PCI 9056AD➔PCI 9056BA Conversion Documentation

This document details changes that designers must be aware of as they convert their PCI 9056AD silicon-based designs to use the latest generation PCI 9056BA. Technical assistance is available at the PLX technical support web page (http://www.plxtech.com/support/default.htm).

5. J Mode ALE Output Timing

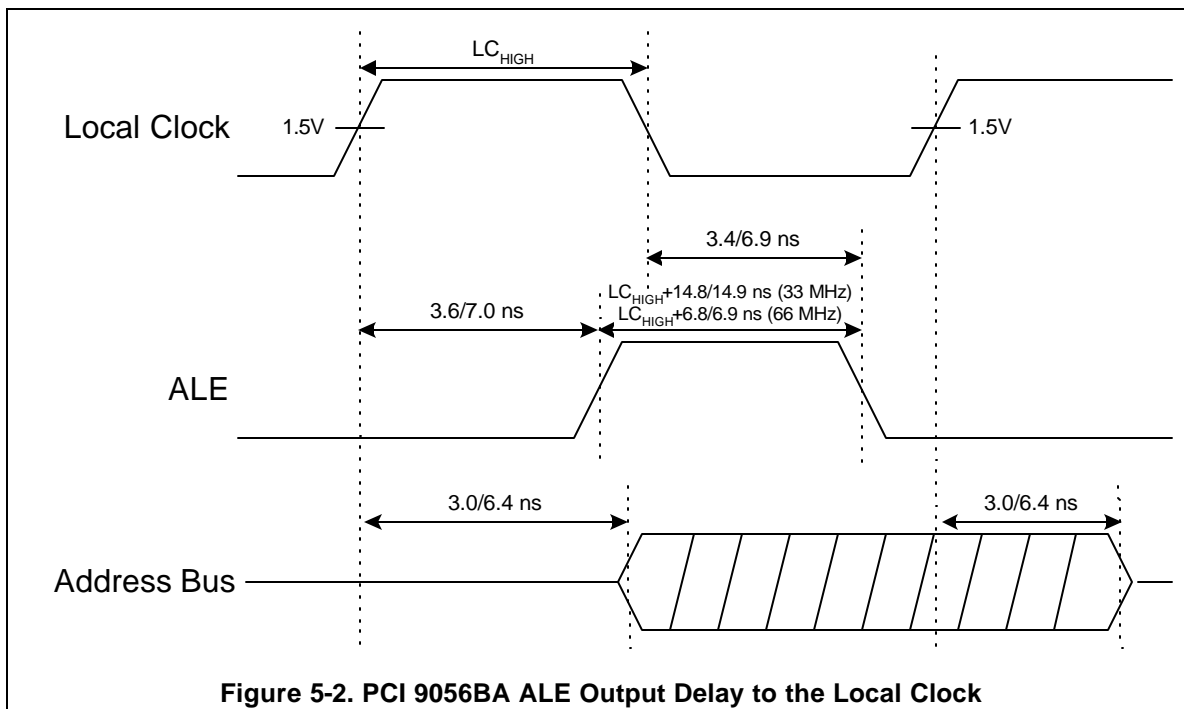
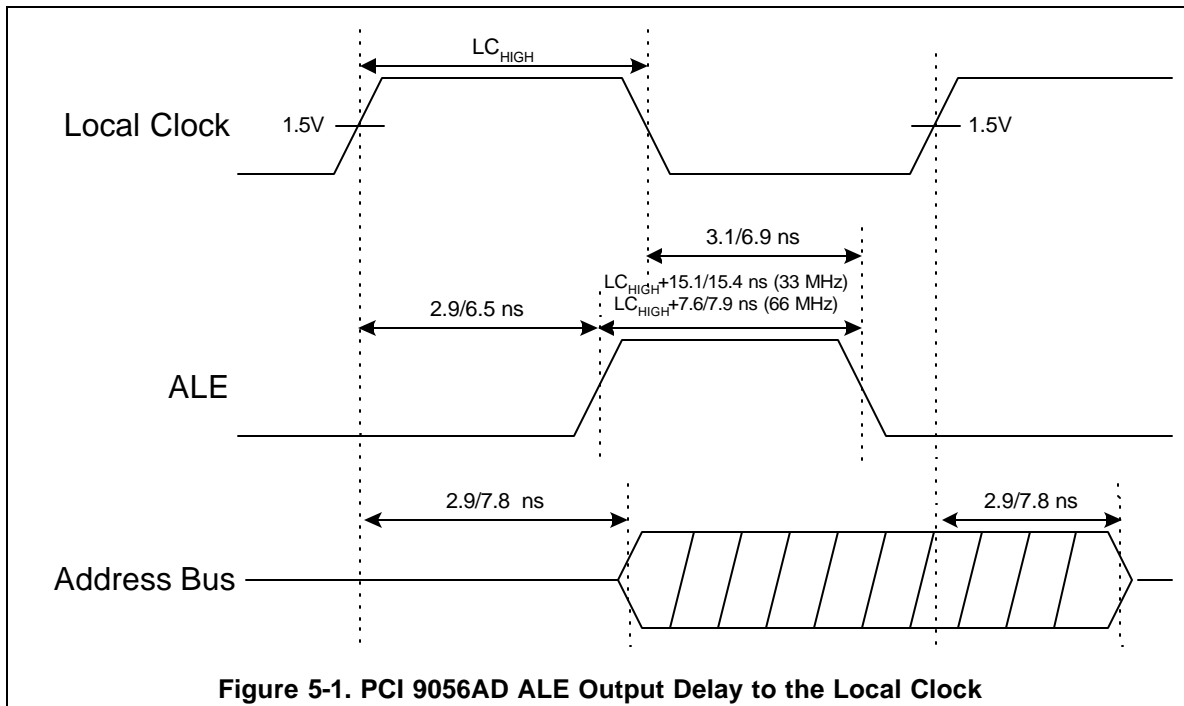
The following figures detail the J Mode ALE signal output timing changes between the PCI 9056AD and PCI 9056BA. LC_{HIGH} is the time in ns that the Processor/Local Bus clock is high.

Figure 5-1. PCI 9056AD ALE Output Delay to the Local Clock

Figure 5-2. PCI 9056BA ALE Output Delay to the Local Clock
